Reference number: Portion 21/195, George  
Date: 06/02/2025  
Enquiries: R Fivaz  
044 801 9350

**APPLICATION FOR REZONING AND SUBDIVISION OF THE FARM PIETER KOEN (KRAAIBOSCH 195/21), GEORGE – ROADS MASTER PLAN.**

Traffic Impact Assessment

# Pieter Koen Development, 195/21, Kraaibosch

Figure 2-2 Proposed Site Access

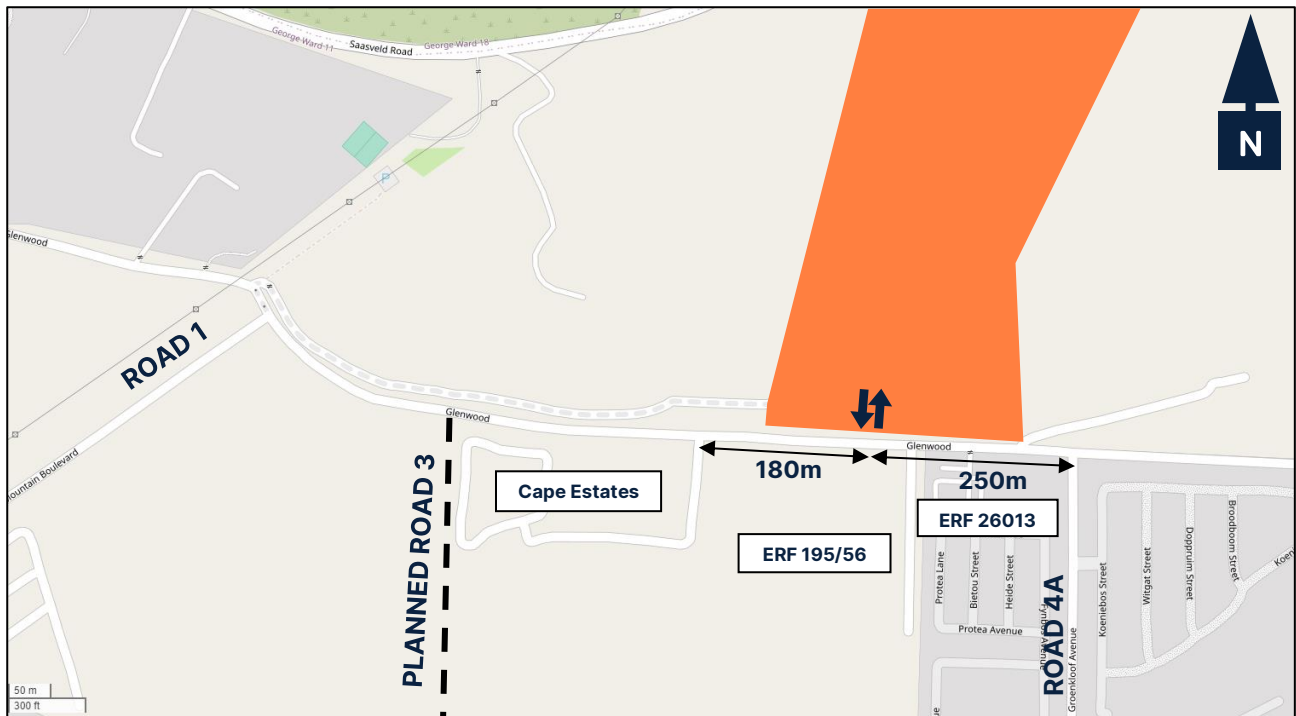
The TIA identifies two substandard access points on the southern edge of Road 2 (adjacent to ERF 195/56 and ERF 26013). In line with the TIA's recommendation, these access points will need to align with the model, ensuring that the access spacing adheres to the specifications indicated in the Kraaibosch Roads Masterplan.
